# Access Compliance Report

## Public Rights-of-Way

### (Curb Ramps)

Intersection ID: N/A	Main Street: HOUSTON_FIELD_CT	Cross Street: SOUTHMORE_DR	Location: SE
ADA ID: 6F73523E54BB	Ramp Type: Directional1	Initial Pass/Fail: Fail	Overall Compliance: No
Codes/Mitigation Info/Possible Solution		Field Measurements/Component Compliance	
Severity Score: 37.5

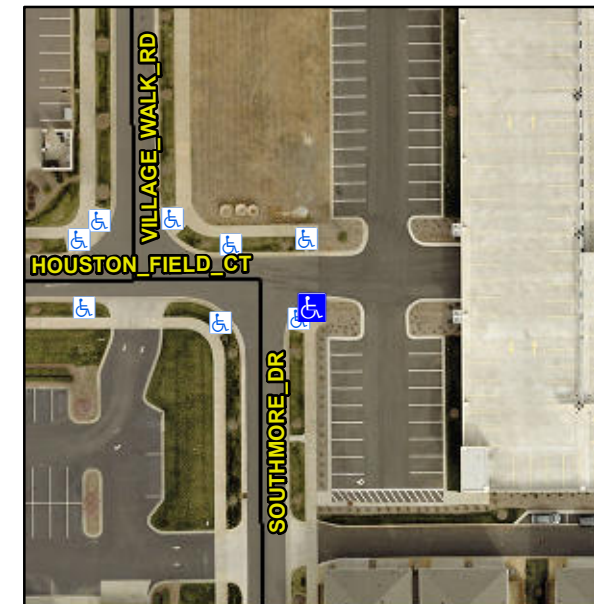
**R304.2.2, R304.5.3**

Compliance	Description	Data	Compliance	Description	Data
N/A	Ramp Length (in)	73.0	N/A	Grade Break?	N/A
Yes	Ramp Width (in)	72.0	N/A	Grade Break Slope (%)	0.0
No	Ramp Slope (%)	8.7	N/A	Grade Break XSlope (%)	0.0
No	Ramp XSlope (%)	7.0			
N/A	Flare Type LT	N/A	N/A	Flare Type RT	N/A
N/A	Flare Slope LT (%)	N/A	N/A	Flare Slope RT (%)	0.0
N/A	Flare Traversable LT?	N/A	N/A	Flare Traversable RT?	N/A
N/A	Landing Length (in)	0.0	N/A	DWS Provided?	N/A
N/A	Landing Width (in)	0.0	N/A	DWS Contrast?	N/A
N/A	Landing Slope (%)	0.0	N/A	DWS Length (in)	N/A
N/A	Landing X Slope (%)	0.0	N/A	DWS Full Width?	N/A
N/A	Landing Curb? (Y/N)	N/A	N/A	DWS Offset LT (in)	N/A
N/A	Shared Landing?	N/A	N/A	DWS Offset RT (in)	N/A
N/A	Gutter Ponding?	0.0	N/A	Gutter Slope (%)	N/A
N/A	Gutter Lip Ht (in)	0.0	N/A	Gutter X Slope (%)	N/A
N/A	Painted X Walk1?	No		Road Slope (%)	4.0
	X Walk 1 Direction	To N		Road X Slope (%)	2.6
	X Walk 1 Width (in)	N/A		Clear Space?	N/A

**Remove & Replace Entire Ramp.**
